## ABSTRACT

This document describes the known exceptions to the functional specifications (advisories).

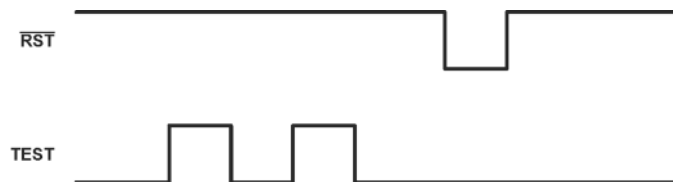
**Description**

The methods used to exit the BSL per MSP430 Programming Via the Bootstrap Loader ([SLAU319](#)) are invalid.

**Workaround**

To exit the BSL one of the following methods must be used.

**SYS10****SYS Module****Category**

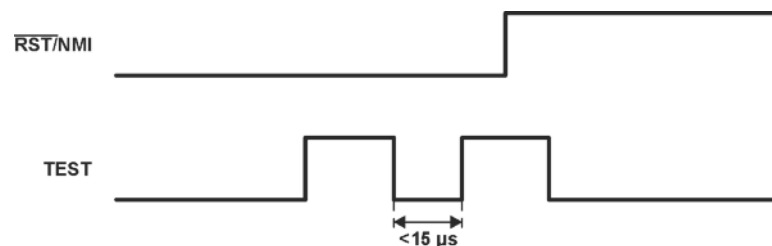
The BSL entry sequence requires that the low phase of the TEST/SBWTCK pin does not exceed 15us. This timing requirement is faster than most PC serial ports can provide, as shown in the following picture. If this requirement is not met, the entry sequence fails and the SYSBSLIND is not set.

**Workaround** An external hardware solution is recommended to provide the appropriate BSL entry sequence. See [http://processors.wiki.ti.com/index.php/BSL\\_\(MSP430\)](http://processors.wiki.ti.com/index.php/BSL_(MSP430)) for recommendations on available BSL hardware.
